**CITY OF SACRAMENTO
DEPARTMENT OF PLANNING & DEVELOPMENT
ZONING ADMINISTRATOR
1231 I Street, Sacramento, CA 95814**

ACTION OF THE ZONING ADMINISTRATOR

On Tuesday, February 11, 1998, the Zoning Administrator approved with conditions a special permit to allow an off-site parking lot under same ownership for additional parking for a retail store for the project known as Z97-124. Findings of Fact and conditions of approval for the project are listed on pages 3-6.

16th ST & BROADWAY
PARKING LOT

EXHIBIT - A

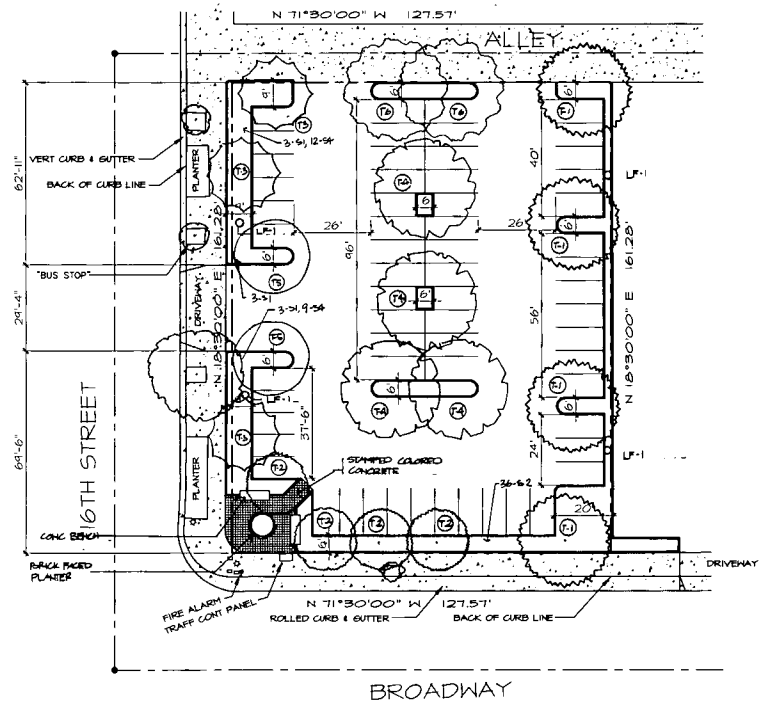
The Publics Works Department conditioned that the applicant remove the driveway off of 16th Street. The staff stated the intersection is too congested due to the complexity of the intersection and the lead lane for boarding Highway 50 at 16th. Additionally staff stated that the proposed driveway is too close to a bus stop along 16th at the project site. The staff summarized that the driveway would cause additional queuing at an already heavily

traveled intersection and therefore, all access to the parking area should be from the alley along the north property line of the site.

At the Zoning Administrator Hearing on January 21, 1998, the applicant contested the condition due to the existence of a driveway for the currently developed site in the same location and that a driveway along Broadway had already been eliminated at the City's and Community Groups' request. The applicant stated the site would no longer have any street access and that the alley was not only in disrepair, but also actually used for parking by the commercial restaurant to the north of the site. The applicant also believed that requiring only alley access would cause confused motorists to take circuitous routes in order to again make a loop back to find the entrance. The Zoning Administrator continued the hearing until January 28, 1998 to further discuss the condition with Public Works.

The Public Works Department staff indicated that the condition should remain. The Zoning Administrator continued the item until February 4, 1998, and again to February 11, 1998, in order for the applicant to meet with Public Works staff to resolve the driveway issue. A compromise was reached allowing the driveway to remain but dedicated for exiting traffic only.

6. **NOTE:** 16th Street and Broadway Route #160 are both part of Caltrans Route 160; therefore, any work that is done on the sidewalks, driveways, curb and gutter will require permits and review by Caltrans. It appears that landscaping along the west property line encroaches into the right-of-way by two feet.

7. The proposed tree canopy in the southeast corner of the project conflicts with existing street light in the sidewalk area. The applicant must resolve the conflict with City Signals and Lighting Division of Public Works (Wesley Hiratsuka, 433-6313).

16. The existing bus stop shall be moved to the north, such that a bus stopped will not block the driveway exit.
17. The applicant shall remove existing driveway on Broadway and construct new curb, gutter and sidewalk at this location.
18. The applicant shall apply for a new driveway permit on 16th Street driveway.
19. The applicant shall reconstruct driveway on 16th Street to be a one-way exit; minimum twelve foot (12') width, maximum 15 foot (15') width.
20. The applicant shall place signs at driveway to advise drivers that this driveway is exit only.
21. The applicant shall replace broken sidewalk as needed.
